CITY OF NORTH OAKS

**Regular City Council Meeting
Thursday, July 08, 2021
7 PM, Via Teleconference or Other Electronic Means Only
MEETING AGENDA**

9b. Consider approval of application for final plan/plat/subdivision for the Island Field Development Site (Site H of the 1999 East Oaks PDA legally described as Tract D, REGISTERED LAND SURVEY NO. 561, RAMSEY COUNTY, MINNESOTA), and associated JPA for water and sewer services with White Bear Township

Exhibit K: Final Utility Plan

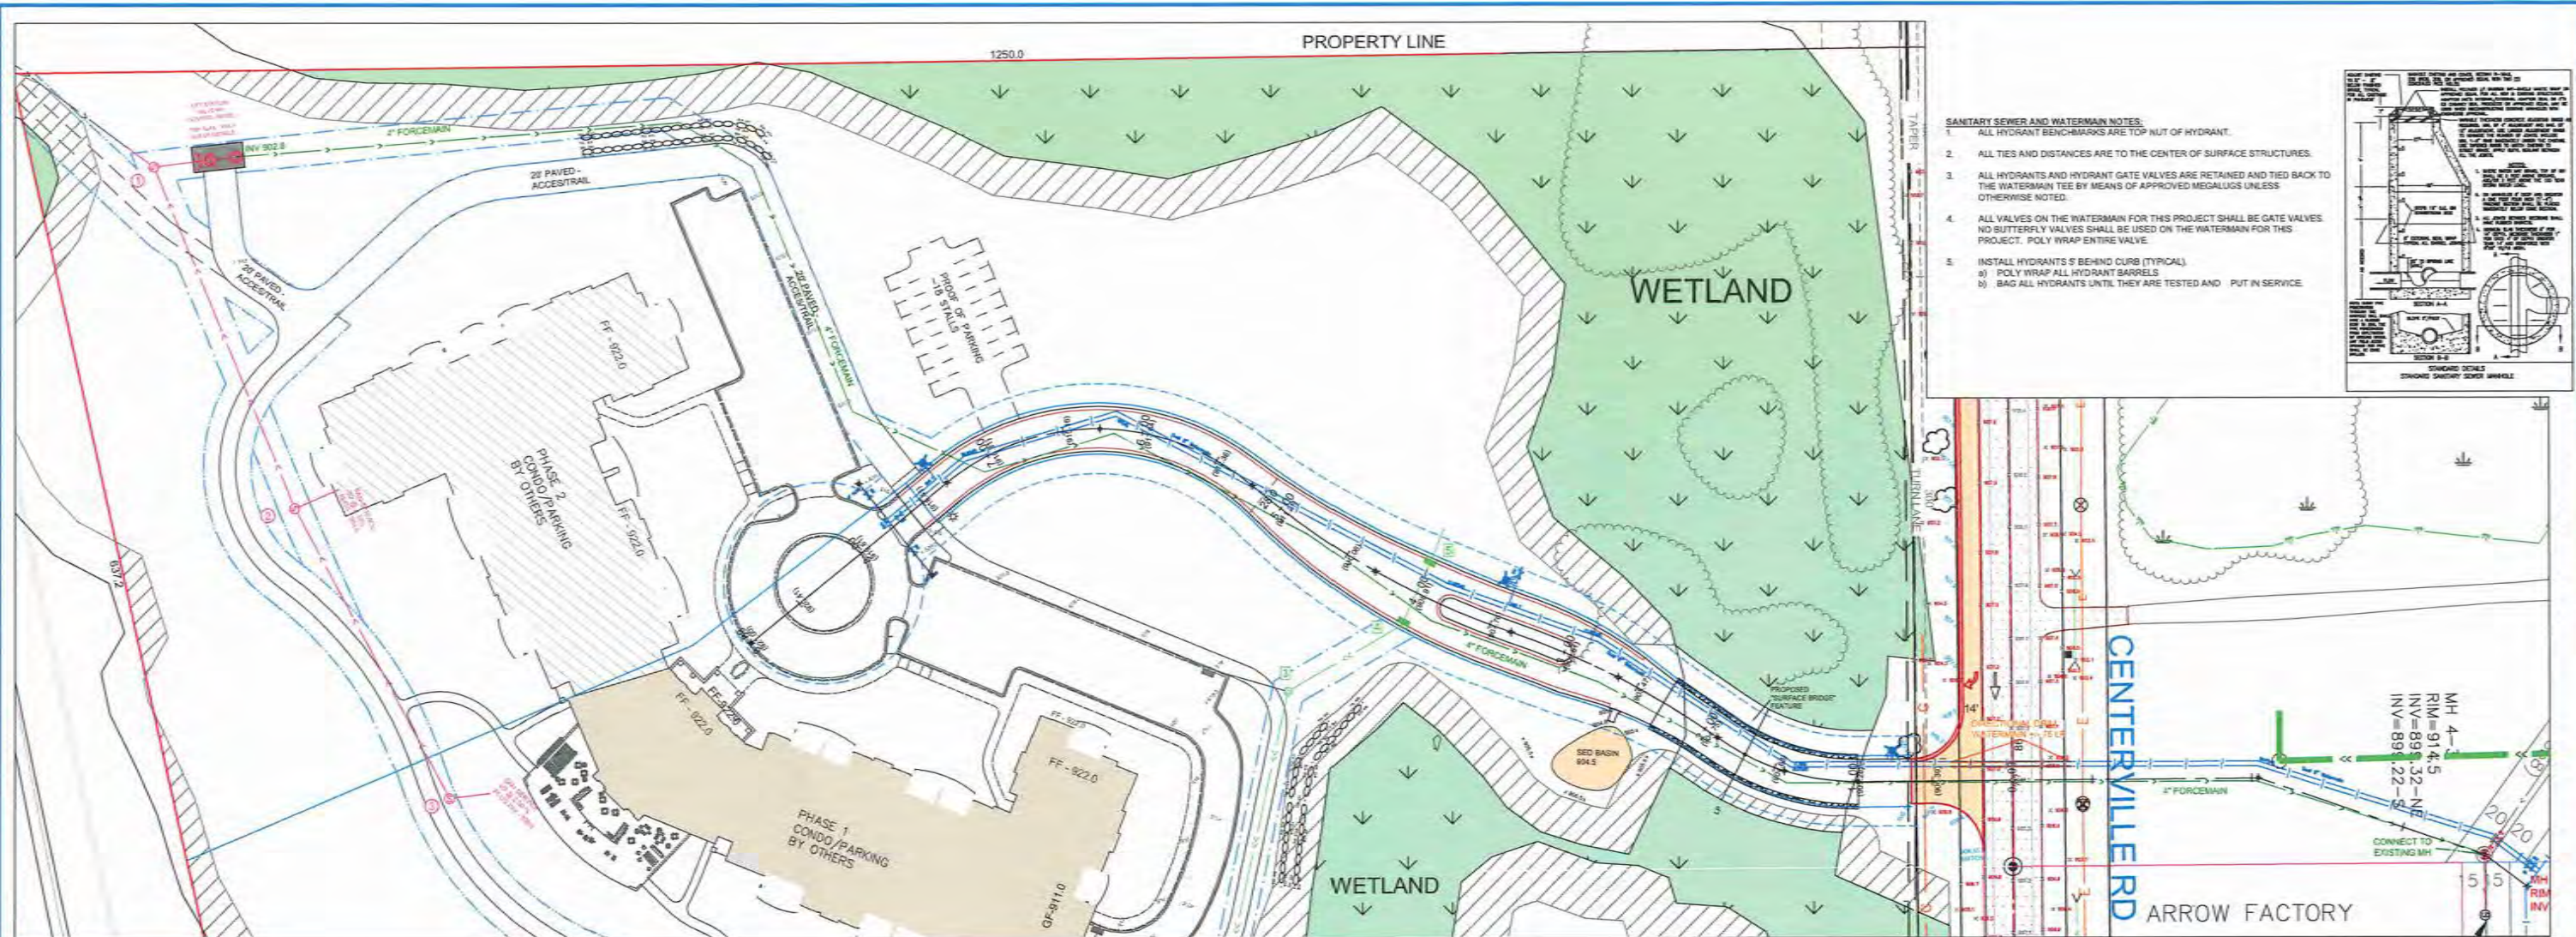
SHEET 5.0 – IF Sanitary Sewer & Watermain Plan (2) (sheets 5, 5B, 5C, 5D)

FINAL PLAT/ STREET PLAN

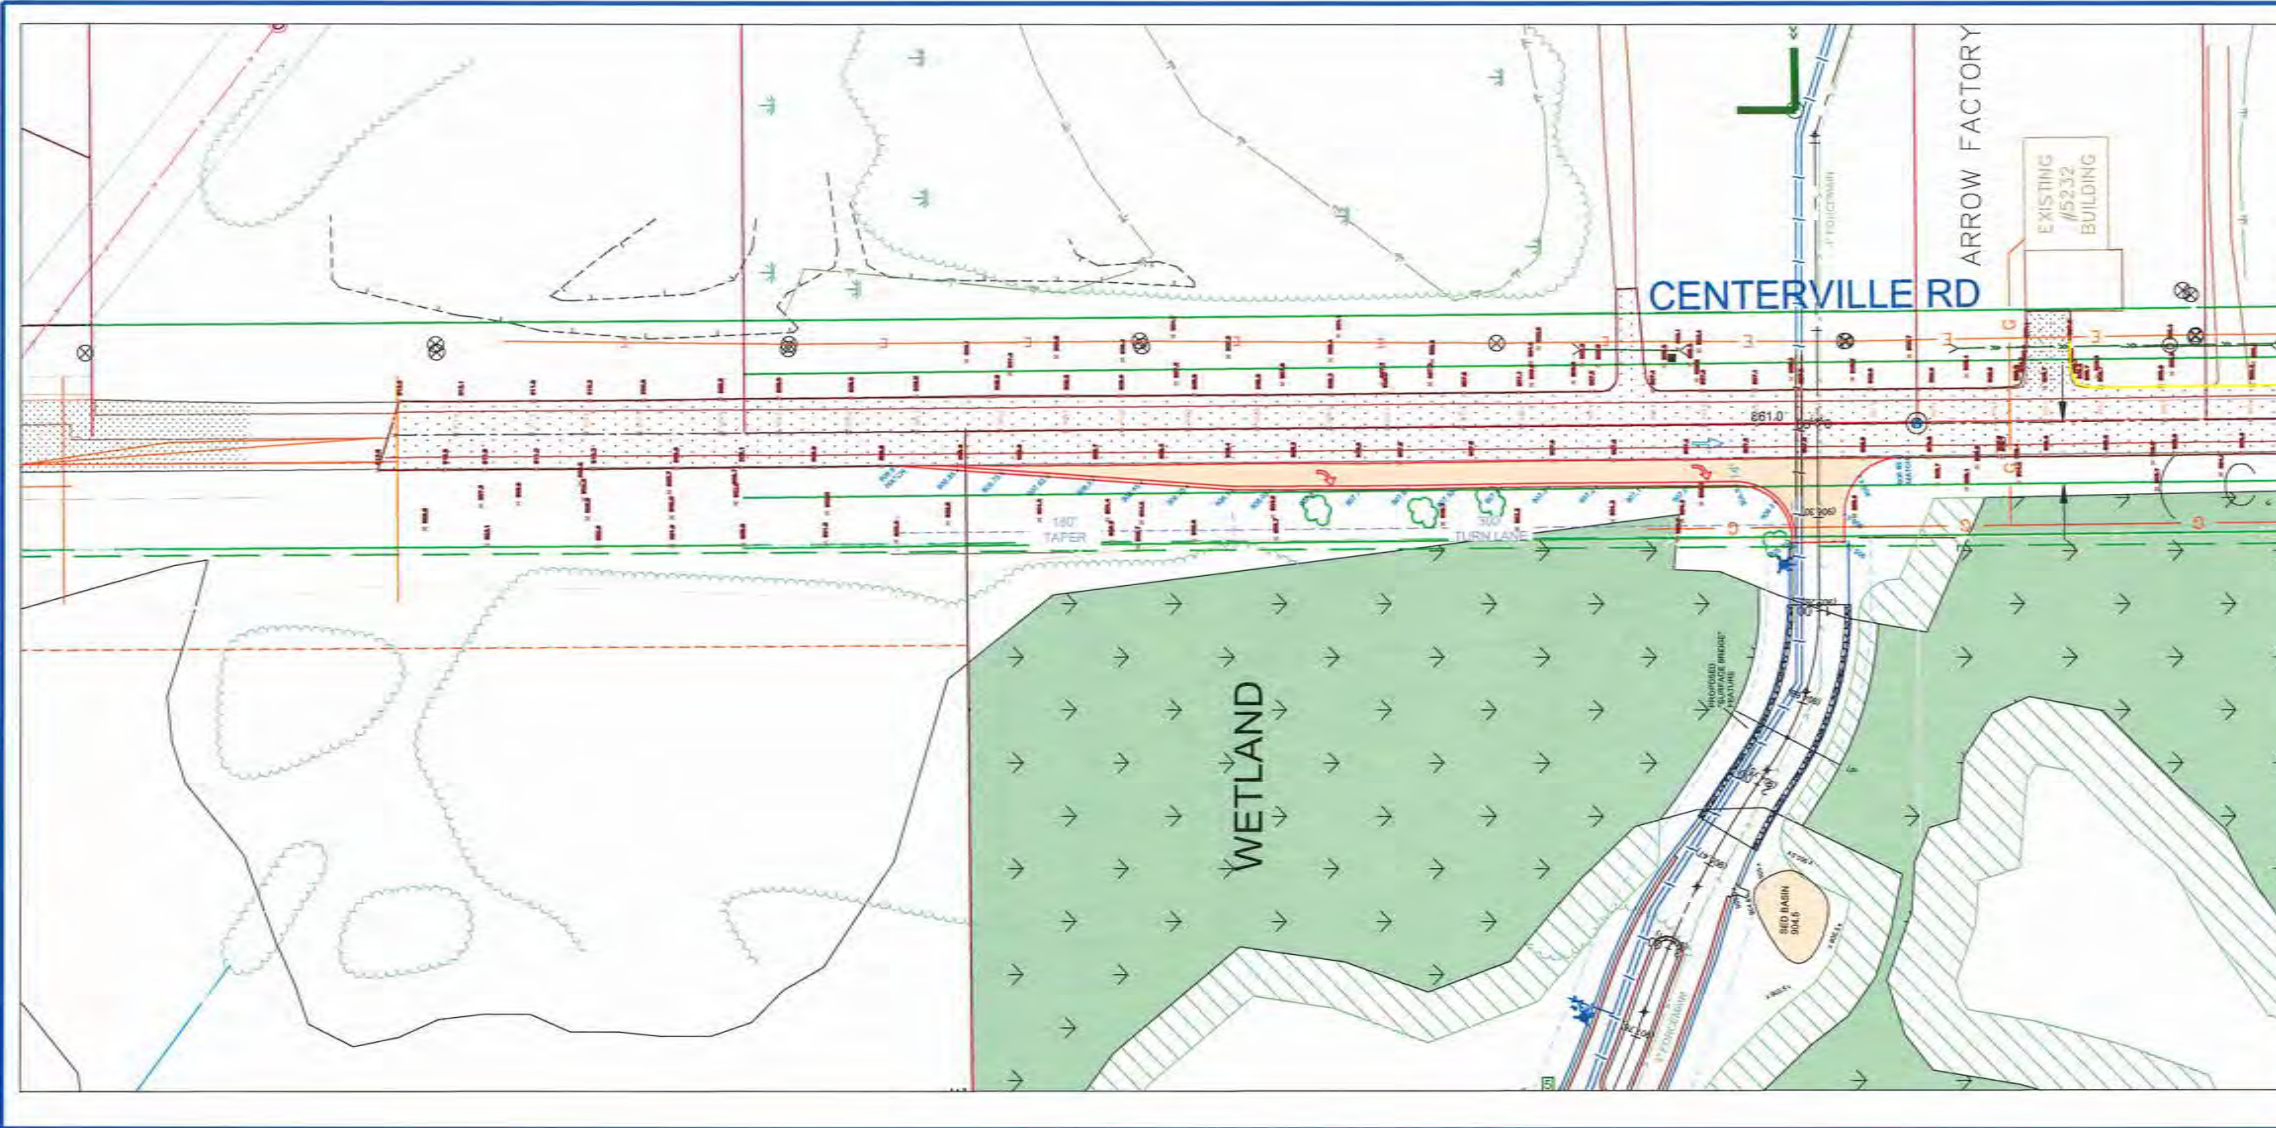
SHEET 5F

- k. Titled as sheet 7- Clarify
